CPUC SUBSTATION AUDIT FINDINGS
PG&E McMaude Headquarters
February 5 – 9, 2024

I. Records Review

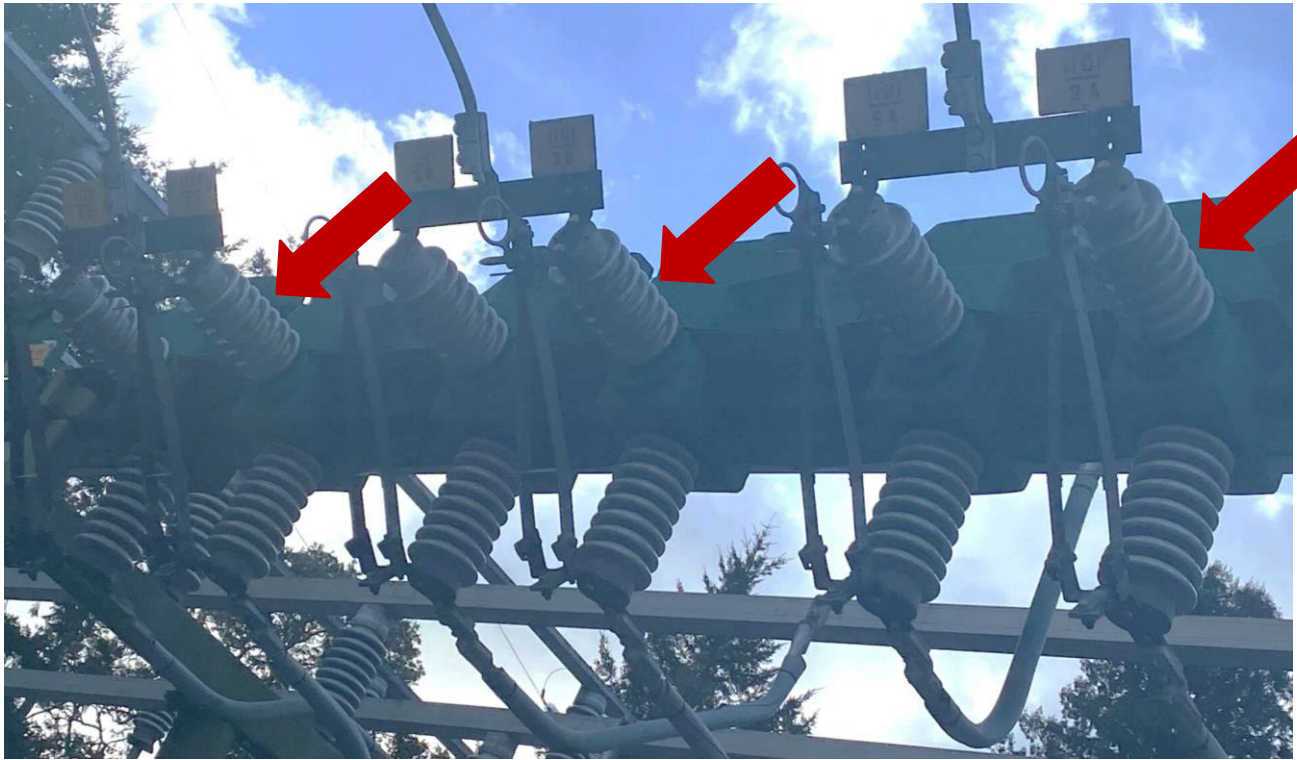
PG&E Response:

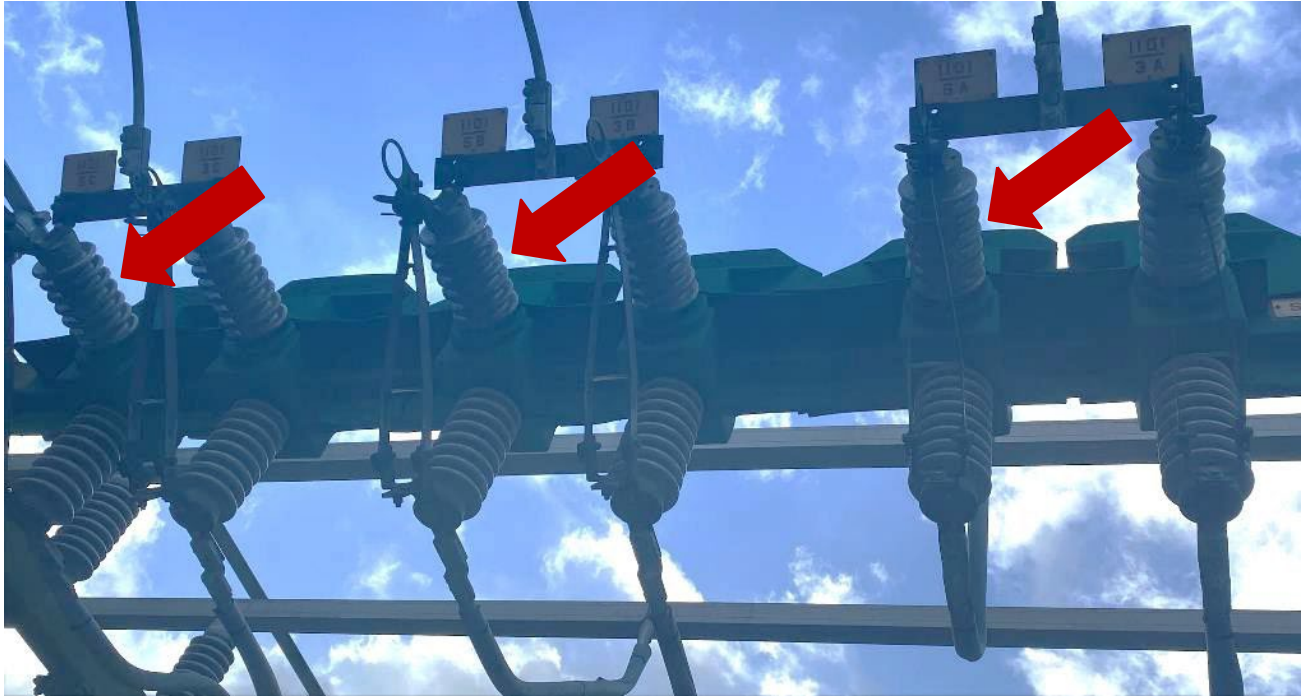
PG&E Response:
